Subject: Response to Portion of NRC Request for Additional Information Letter No. 256 Related to ESBWR Design Certification Application – Instrumentation & Control Systems - RAI Number 7.1-131

RAI Number 7.1-131

DCD and Licensing Topical Report Markups for RAI Number 7.1-131

Event Diagram: 15.1-40

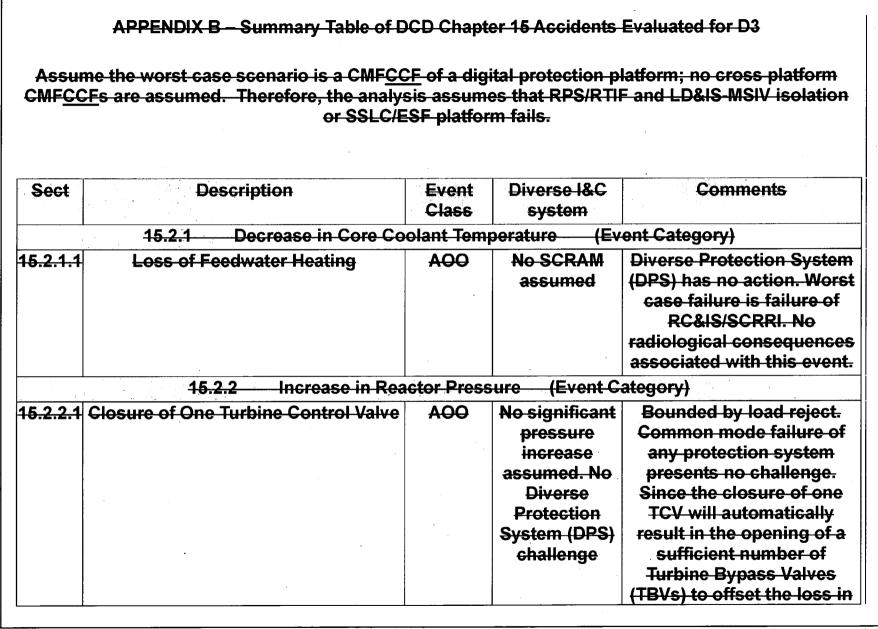
<u>Event Analysis</u>: Controlled evolution. Normal operating systems <u>are</u> assumed to be available. This event does not involve the RPV or containment and requires no actions from RPS<u>. SSLC/ESF</u>, andor DPS. Conclusion: No adverse consequences.
